Alaska Department of Environmental Conservation

18 AAC 50 AIR QUALITY CONTROL

Response to Comments on October 15, 2015 Proposed
Regulations Changes and State Air Quality Plan Amendments

December 17, 2015

f. Section C.2.d – Regional Haze BART Control

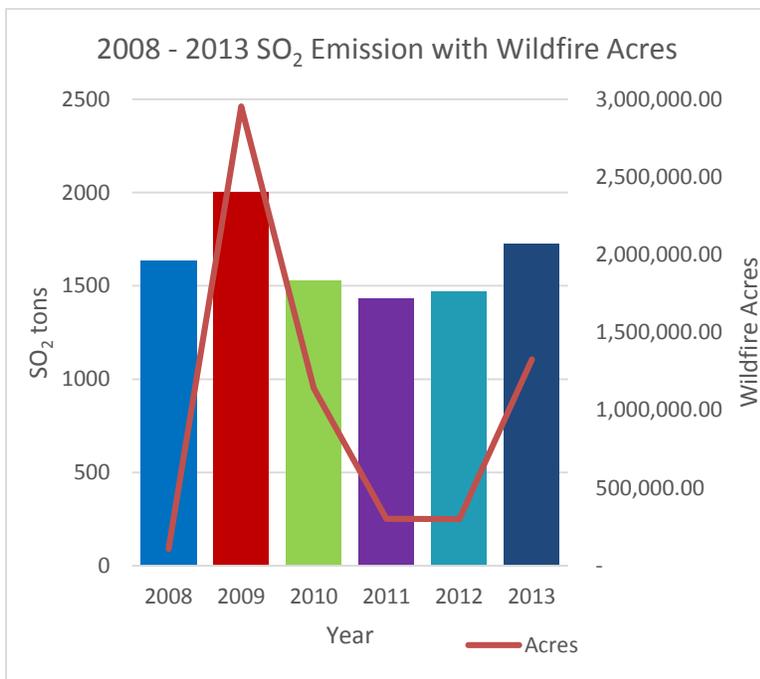
EPA Comment: This should be revised to reflect that it has already occurred and also that it occurred outside of the most recent 5-year period considered in this review.

DEC Response: Unit 2 was brought online on May 28, 2015. It first ran on coal on August 4, 2015. GVEA anticipates commercial operation by 2016.
